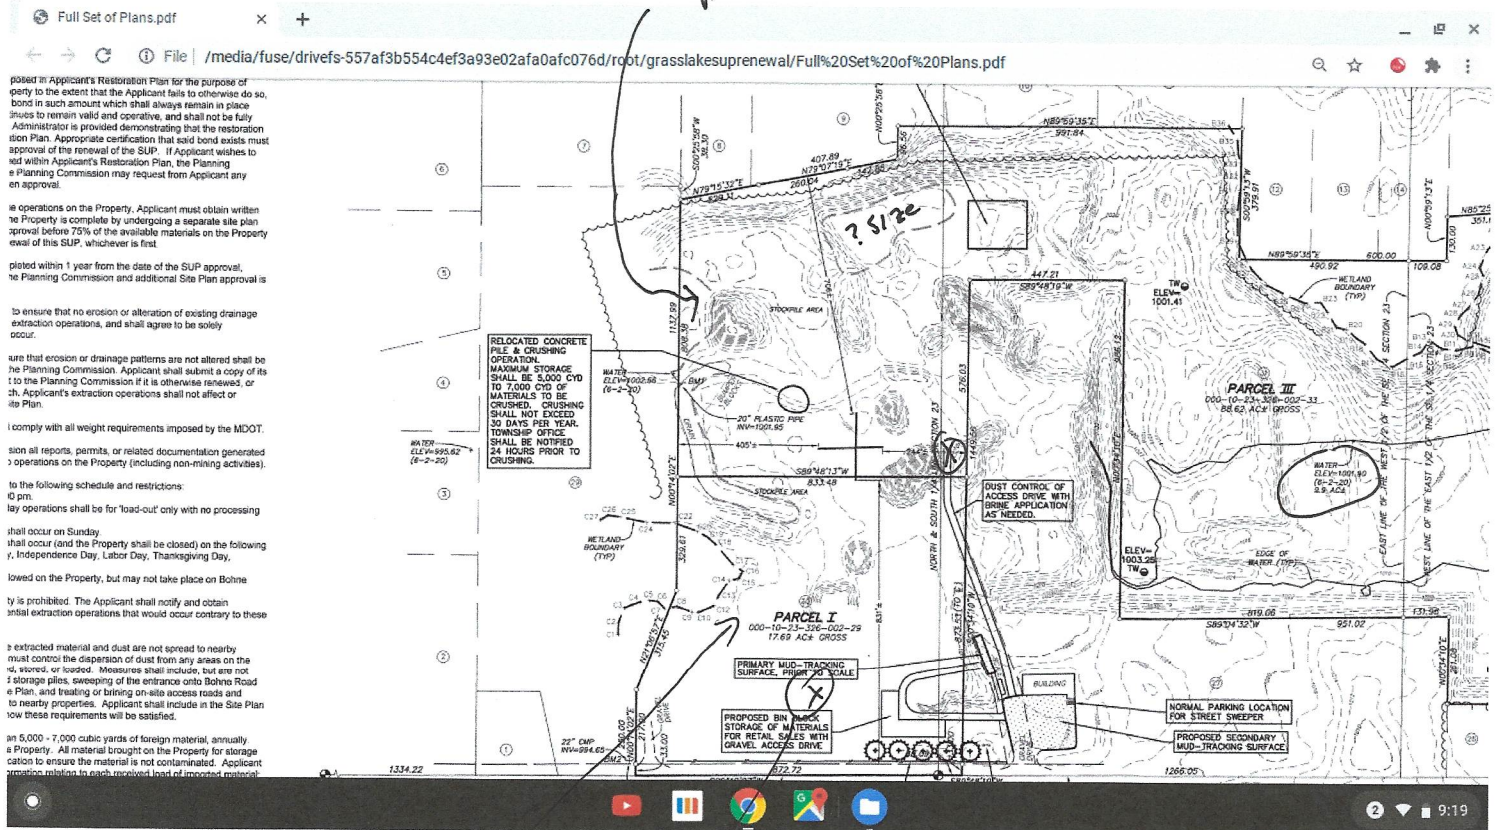
line to 2nd lake
dredge for
mining

2nd
lake

line from
dredge

outlet
for dredged (mined)
material

Small lake MISSING

? size

destroyed wetlands

MISSING remains of wetlands

- use need contours for post mining
- End Use
 - residential
 - high water
 - no land available
 - need to submit plan
 - Agricultural
 - where - mostly water
 - shallow ~~ground~~ gw
 - no vadose zone
 - fertilizer 1/1
